m e m o r a n d u m

FROM: Jeff Engstrom, AICP, Planner II

DATE: November 15, 2013

SUBJECT: Plan Case No. 2217-S-13: Verdant Prairies Village Subdivision Preliminary Plat

PRELIMINARY PLAT VERDANT PRAIRIES VILLAGE

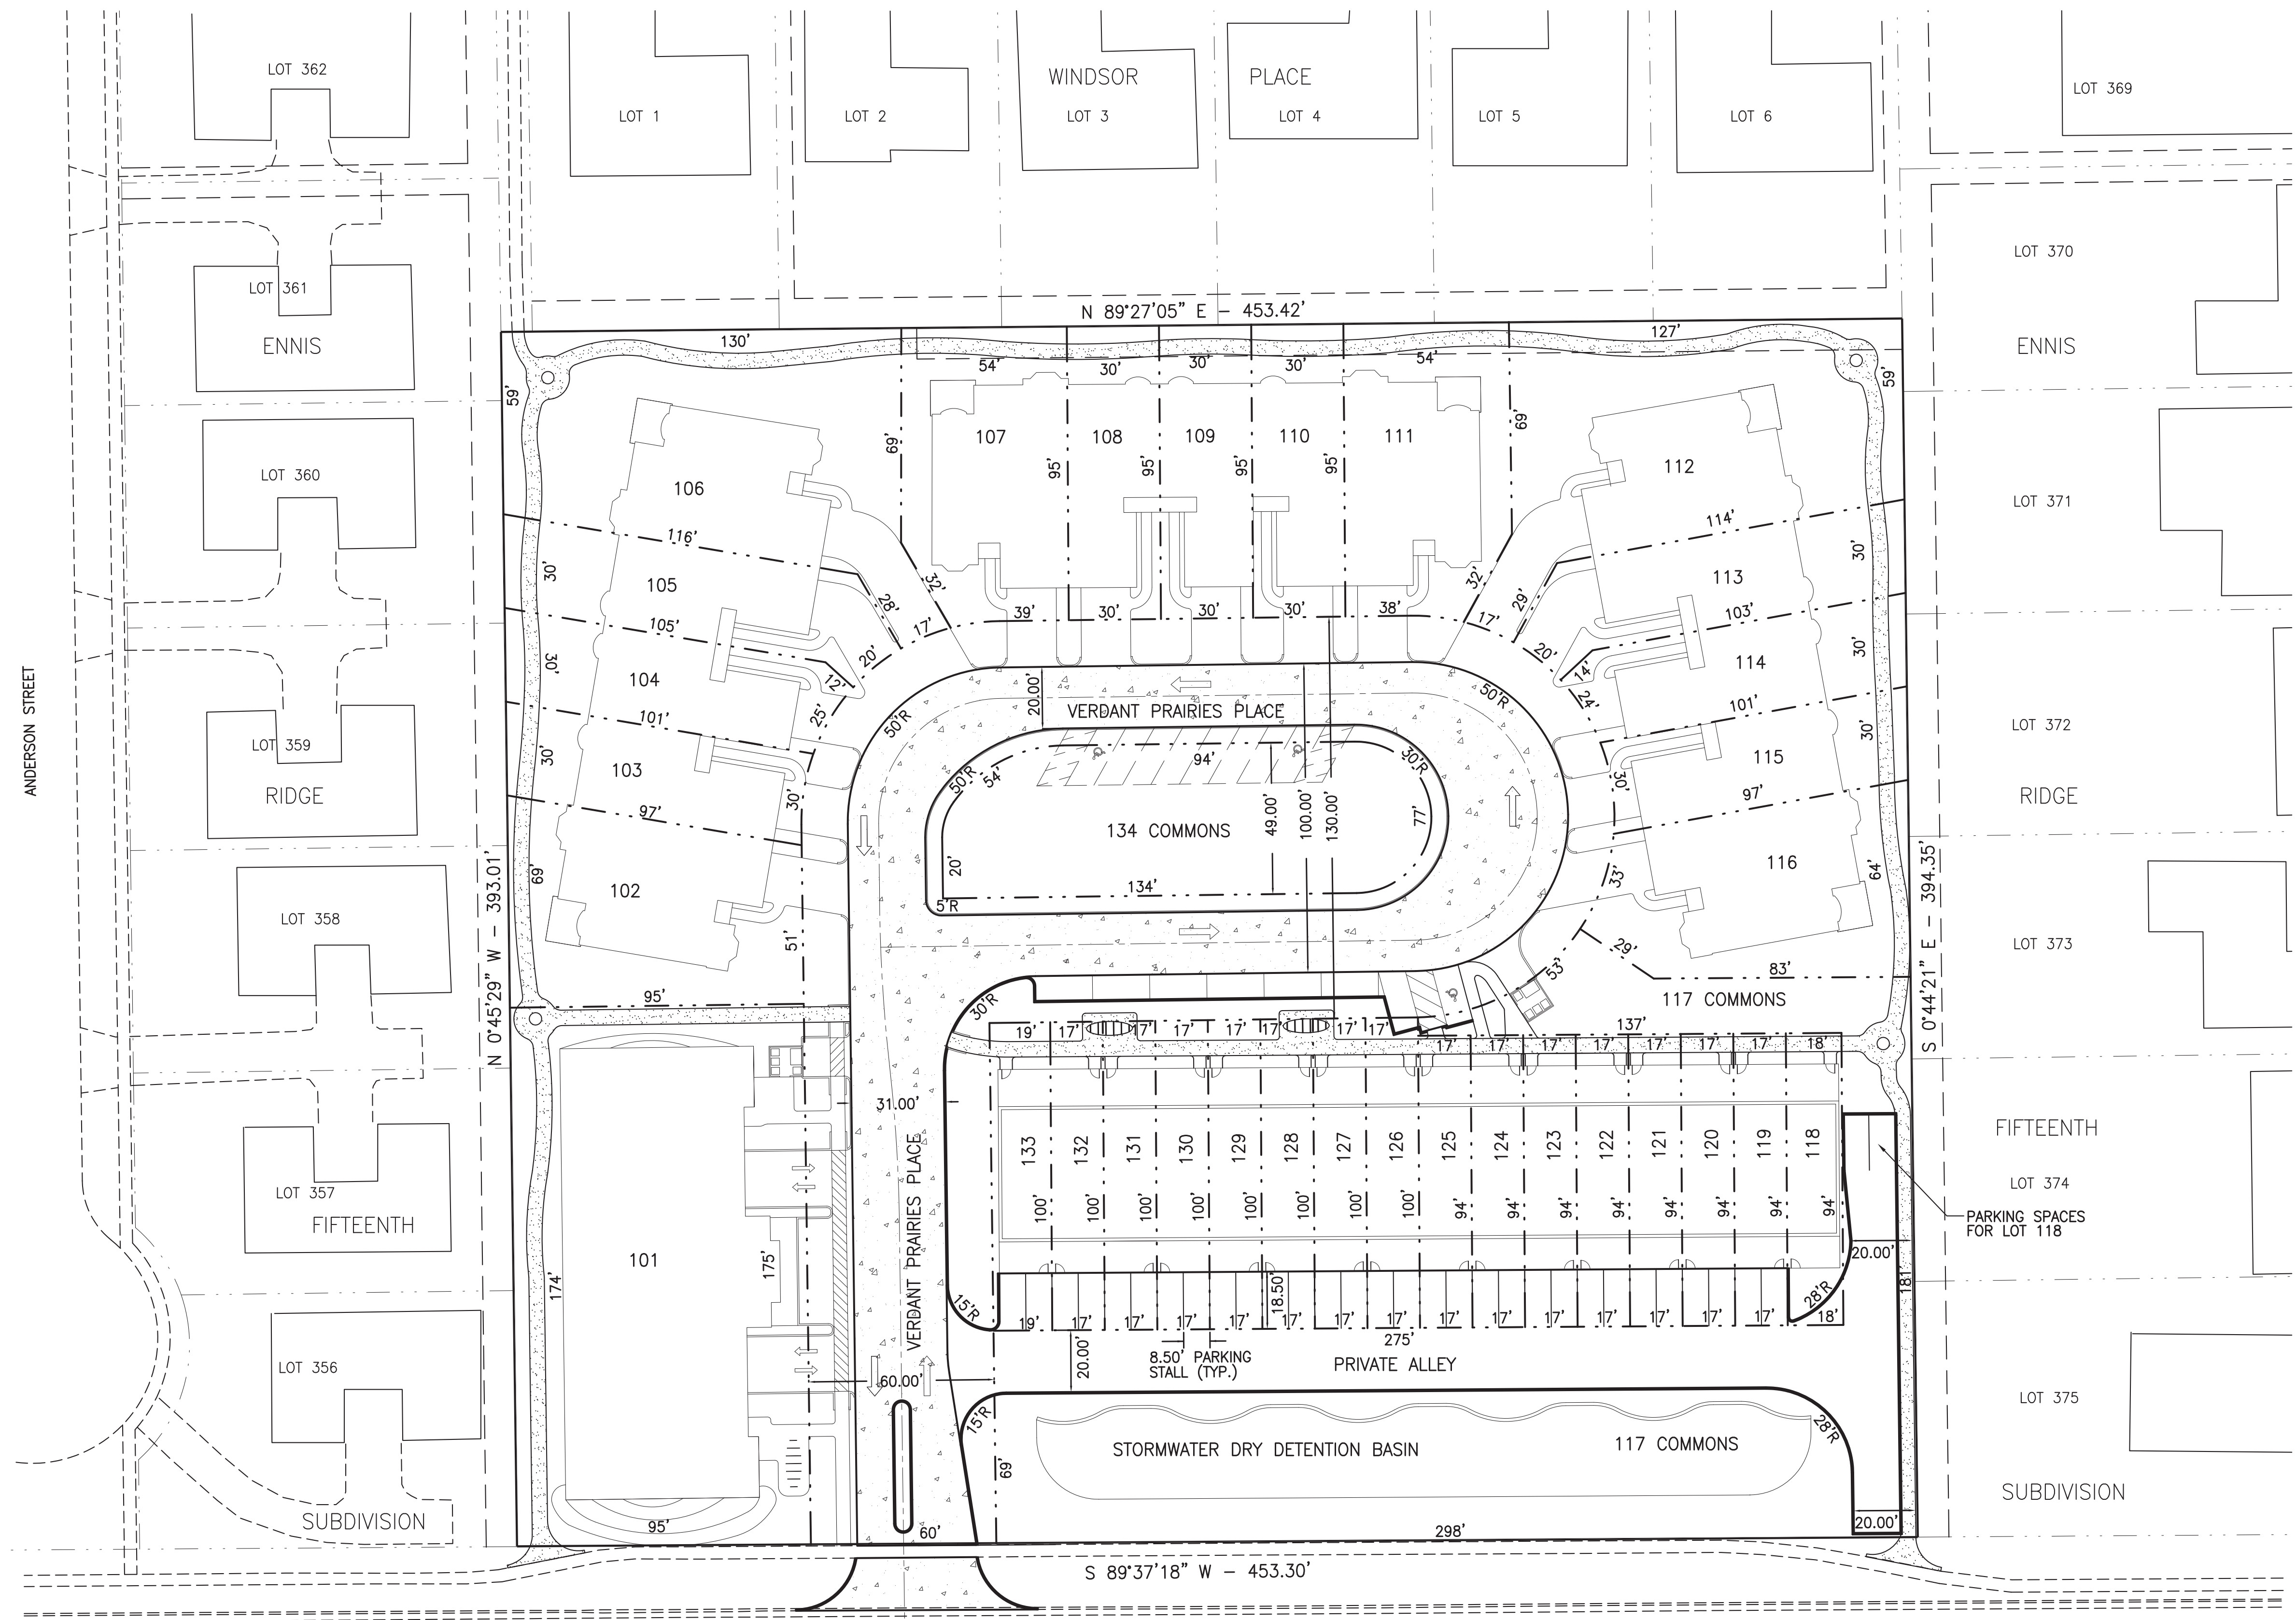
Waiver A: The requirement for each lot to be adjacent to a public street. This request is driven by the number of lots on the site. The request would allow for six of the smaller townhouse lots to be accessed from a sidewalk in front and from a private alley in the rear. Staff supports this request, as the front door and parking for each lot would still be easily accessible. The Fire Department would

still have access to both sides of the townhouses, but the farthest unit, Lot 118, would be set back approximately 100 feet from the street. The built configuration is no different from what would be allowed by right if the townhouse units were all on a single large lot with one owner. Such a configuration exists elsewhere in the City.

Waiver B: The reduced setback from a public street for a detention facility. The detention basin should be set back about 20 feet from the Windsor Road right-of-way, but is only set back eight feet. This has been mitigated through design features. The applicant has agreed to install warning signage, add a nine-inch barrier curb along the south side of the alley adjacent to the detention basin on the north, and install a hedge row along the Windsor Road right-of-way to protect pedestrians. With these features staff supports this waiver request.

Waiver C: The request to not provide sidewalks around the circle drive portion of Verdant Prairies Place can be attributed to the layout of the site and the requirement for each townhouse lot to have private parking (and therefore a driveway). There are so many driveways along the outside of the circle drive that a sidewalk could be dangerous. A sidewalk along the inside of the circle drive would likely not ever be used, as it would not be adjacent to any residences. Staff recommends approving this waiver, as each lot in the development will be adjacent to a sidewalk or the perimeter walkway.

Waiver D: The request to reduce the width of the access portion of some lots from 20 feet to 17 feet. This request is again related to the difficulties of providing so many lots on a constrained site in a developed neighborhood. This layout would potentially be allowed by right for the northern half of the development if the townhouse units shared one large parcel. As the plat has been drawn, there are some lots (106 and 112) that only have a narrow access portion. The remainder of each of these lots is quite wide though (they are the largest lots in the entire development), so staff recommends approval of the waiver. For Lot 118 through 133, the width of the entire lot is only 17 feet. Under a common ownership model these units would be allowed to have this narrow width. Given that each unit has outdoor green space and room for two parking spaces, staff supports the requested waiver.

Waiver E: The request to allow a private alley to access Lots 118 through 133: The reason for this requirement in the subdivision code is that maintenance of a private alley could be difficult for disparate adjacent owners. However, this alley will be maintained by the subdivision's Home Owner Association from the beginning. This alley is needed to accommodate townhouse lots that do not have frontage on Verdant Prairies Place. Staff supports the private alley as a solution to provide required access to each lot given the difficult lot configuration. The alley will be built to public standards, including a hammerhead turnaround at the end which is large enough to accommodate a City fire truck.

Based on general conformance with the Urbana Subdivision and Land Development Code and Comprehensive Plan and the necessity of the requested Subdivision Ordinance waivers, Staff recommends that the Plan Commission recommend City Council APPROVE the Preliminary Plat and requested waivers.
